RESPONSE TO QUESTIONS RAISED BY RIVERKEEPER, INC.

REGARDING SEISMIC HAZARD ANALYSIS AT

INDIAN POINT NUCLEAR GENERATING UNIT NOS. 2 AND 3

The questions and comments presented in the August 12, 2004, letter, with attachment, from Riverkeeper, Inc., and the Nuclear Regulatory Commission (NRC) staff responses are as follows:

Figure 1. Earthquake activities near Indian Point since 1974. Historical earthquake epicenters are based on FSAR, 1985.

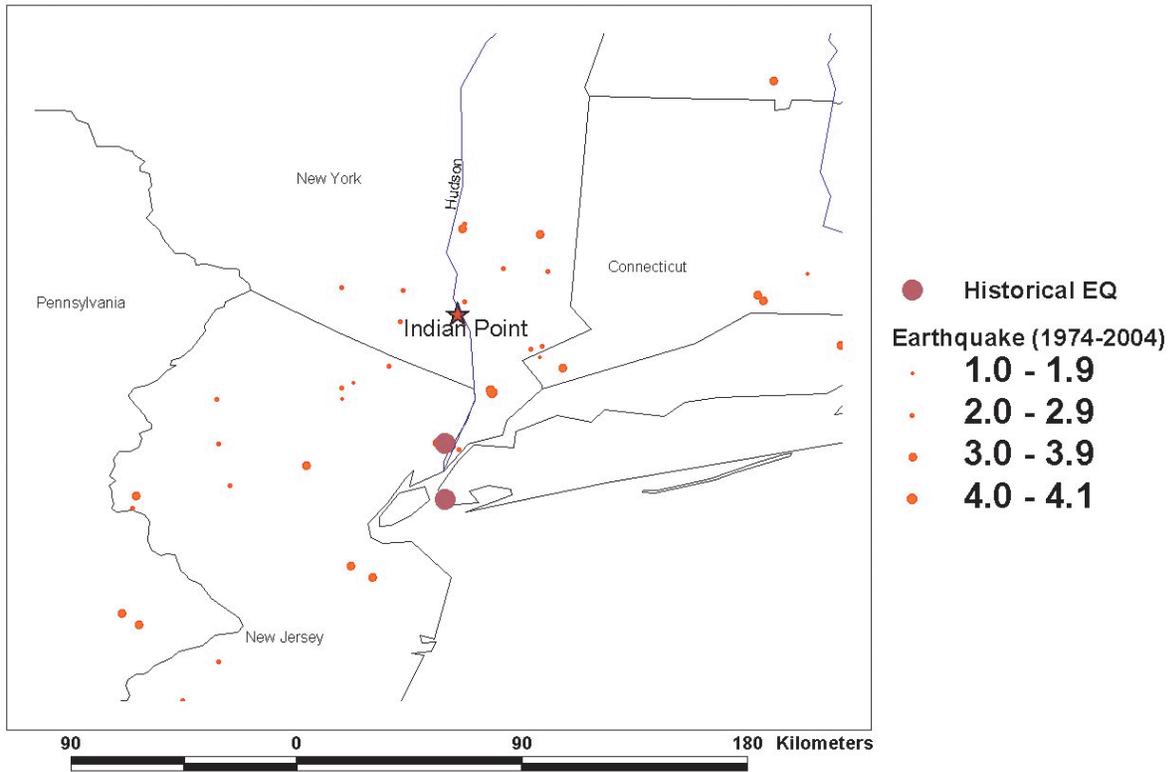
1. A great deal more information on earthquakes has become available since the hazard analysis that was performed decades ago regarding the risk of damage to Indian Point posed by seismic activity. For example, a sequence of earthquakes started in August 2003 is being studied by the Lamont-Doherty Earth Observatory near the New Jersey and Pennsylvania border about 75 miles southwest of Indian Point. These earthquakes are particularly pertinent to the potential for earthquakes near Indian Point because they are associated with the same fault system (the Ramapo fault).

The attached Figure 1 shows the seismic activity, since 1974, in the area within a 200 km radius of Indian Point. There are a total of 63 events that occurred during the period, with magnitudes ranging from 1.1 to 4.1. The earthquake catalog is based on the U.S. Geological Survey (USGS) National Seismic Network. Only two earthquakes have occurred (magnitude 3.8 on August 26, 2003, and magnitude 2.4 on October 1, 2003) near the border between Pennsylvania and New Jersey. There is no obvious earthquake sequence based on the seismic catalog for the border area. Furthermore, these earthquakes are not necessarily associated with the Ramapo fault because the earthquake epicenters project farther north than the fault traces. Earthquakes with magnitudes less than 5 are unlikely to cause any damage to nuclear power plant facilities because of the stringent design requirements for nuclear power plant structures and associated equipment. Larger earthquakes have occurred before 1974 (when seismic instruments were used to register seismic events). The two largest earthquakes, with magnitude of about 5.2, occurred in 1737 and in 1884, respectively, but their locations are uncertain (Figure 1 shows the estimated coordinates provided in Indian Point 2 Updated Final Safety Analysis Report (UFSAR)). Earthquakes of this size, often can cause damage, such as chimney collapse and cracks on the walls in residential buildings, but are unlikely to cause any noticeable damage to a nuclear facility.

Some of the cataloged earthquakes occurred in an area that might be related to the Ramapo fault system, based on the spatial relationship between the fault system and the earthquakes. The Ramapo fault system is a group of Mesozoic age faults, extending from southeastern New York to northern New Jersey, as well as further southwest. The fault system is composed of a series of southeast-dipping, northeast-striking faults. Various faults of the system contain evidence of repeated slip in various directions since Proterozoic time, including Mesozoic extensional reactivation. However, the USGS staff, who reviewed 31 geologic features in the Appalachian Mountains and Coastal Plain and compiled a National Database on Quaternary

Figure 2. Design spectra and potential ground motion at the Indian Point site.

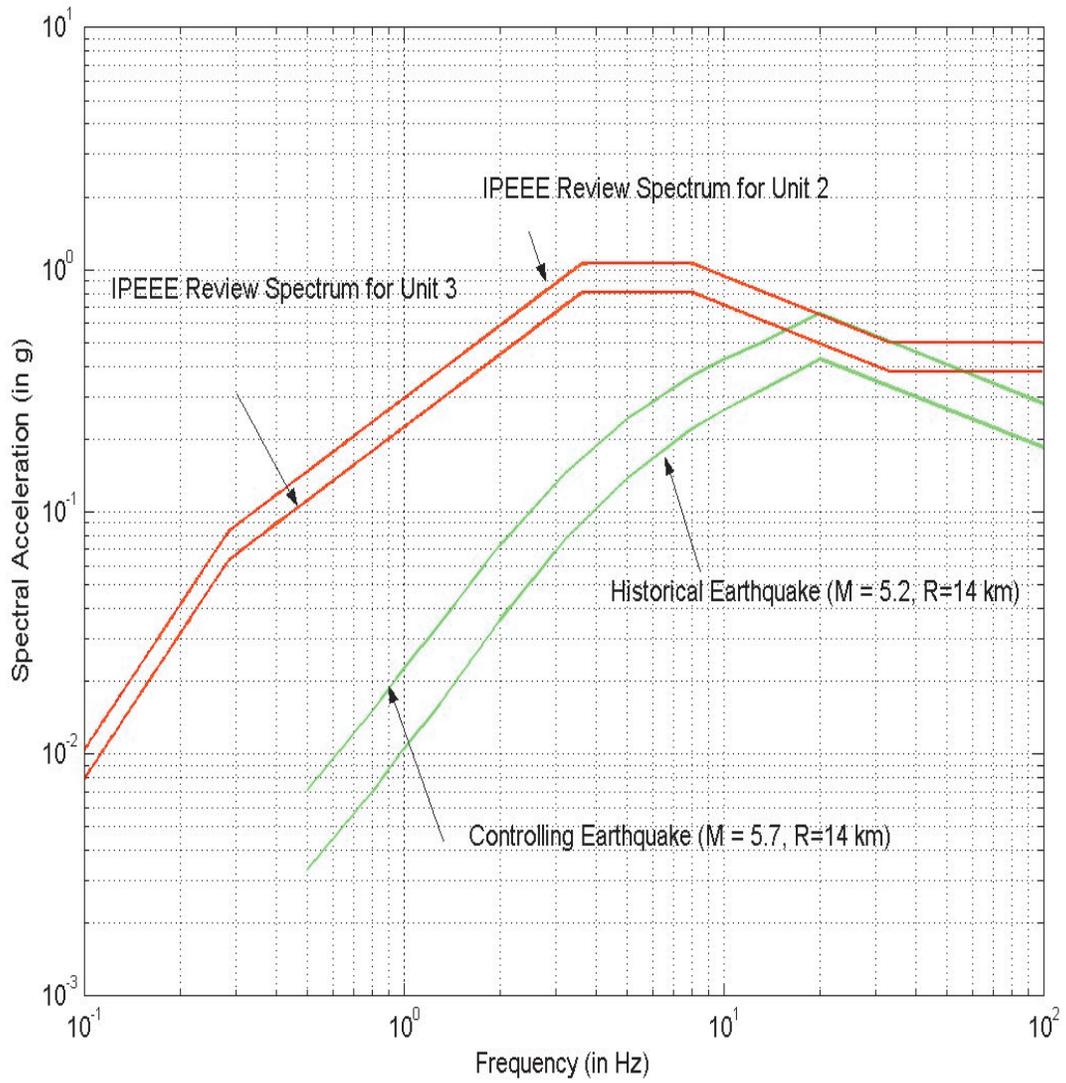
4. But it is obvious that the seismic hazard analysis for Indian Point- which is situated adjacent to the Ramapo fault- clearly needs to be updated.

Figure 2, attached, shows (a) the IPEEE review spectra anchored at 0.5 g and 0.38 g for Units 2 and 3, (b) the controlling earthquake (based on LLNL, magnitude of 5.7 at a epicentral distance of 14 km and assumed depth of 10 km) ground motion spectrum (with a reference probability of 10^{-5}), and (c) the historical earthquake (magnitude of 5.2 at a epicentral distance of 14 km and assumed depth of 10 km) ground motion spectrum. For the ground motion prediction relative to both controlling and historical earthquakes, the NRC staff used an Atkinson and Boore attenuation relationship (Atkinson and Boore, 1995). A comparison of these spectra shows that both the controlling earthquake and the historical earthquake are enveloped by both IPEEE review spectra for Unit 2 and 3 up to about 15 Hz, although IPEEE review spectrum for Unit 3 is lower than controlling earthquake at about 15 Hz. Since the natural frequency range for most structures and equipment at nuclear power plants falls below 10 Hz, ground motions above 15 Hz will not likely damage major structures, systems, and components at Indian Point. High frequency ground motion above 10 Hz generally affects active components such as relays and contacts, which are subject to chatter. Relays and components, with high frequency sensitivity, have been explicitly addressed in IPEEE evaluations.

Figure 3. Au Sable Forks earthquake strong motion records are in agreement with several attenuation relationships (Atkinson and Sonley, 2003). AB95: Atkinson and Boore, 1995; C2002: Campbell 2002; S2002: Somerville, et al. 2002; T97: Toro et al., 1997.

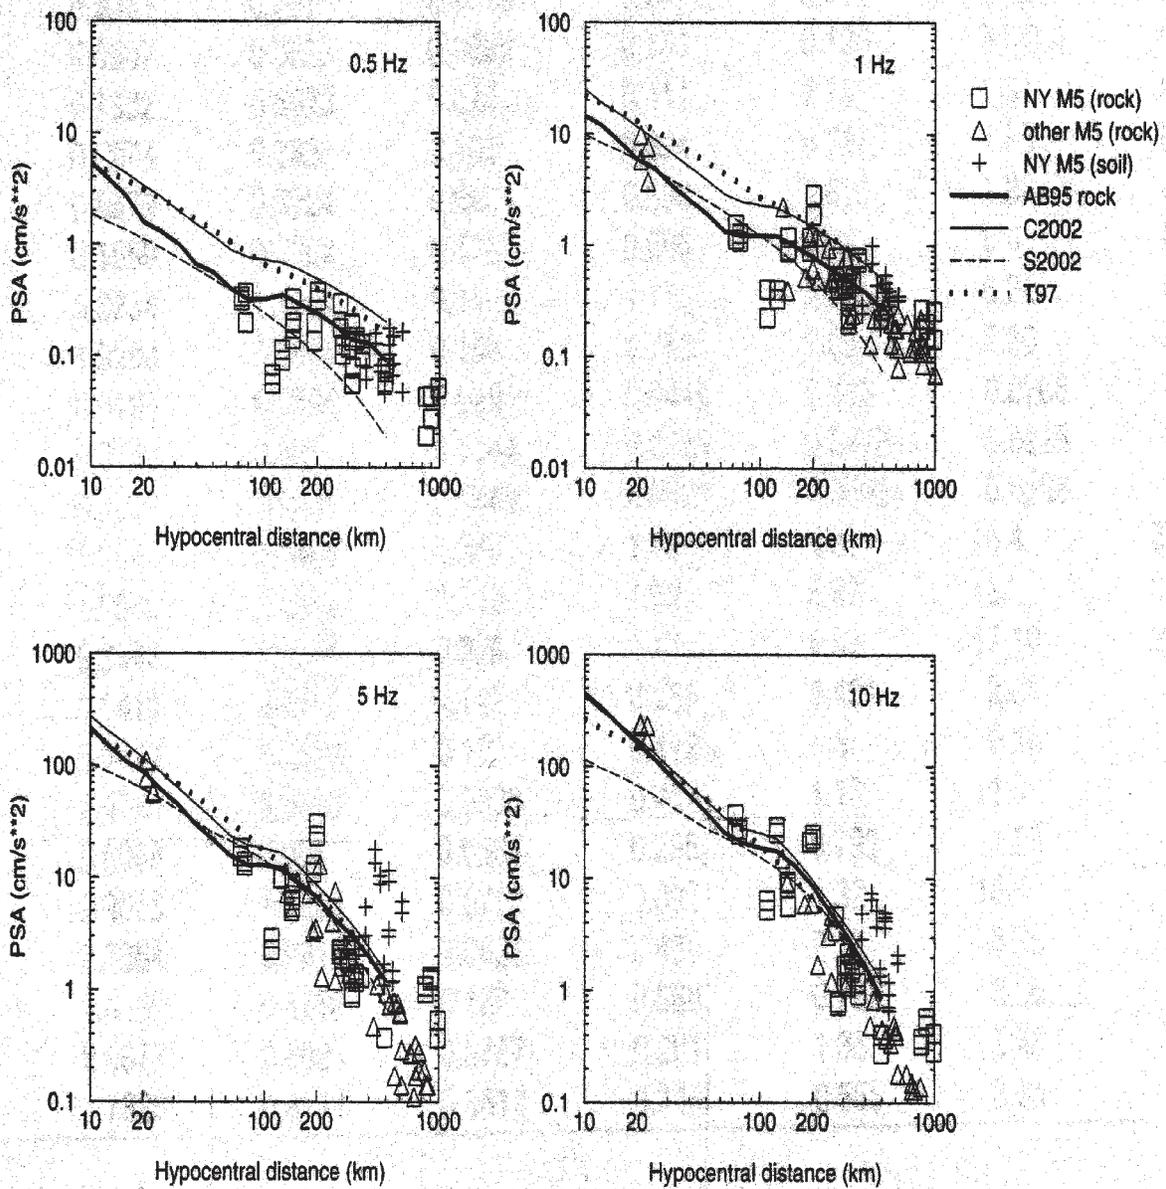
7. New data, for example, are now available for the 2002 Au Sable Forks, Adirondacks NY shock, which was of similar magnitude to the 1884 New York City earthquake.

Strong motion records from one earthquake usually do not significantly change an attenuation relationship. Moreover, seismologists continually update their attenuation relationships, as more strong motion recordings become available. Strong motion data from the Au Sable Forks earthquake had been used in comparing several existing attenuation relationships (Atkinson and Sonley, 2003). The result indicates that the data are in agreement with those attenuation relationships currently used for the CEUS (Figure 3).
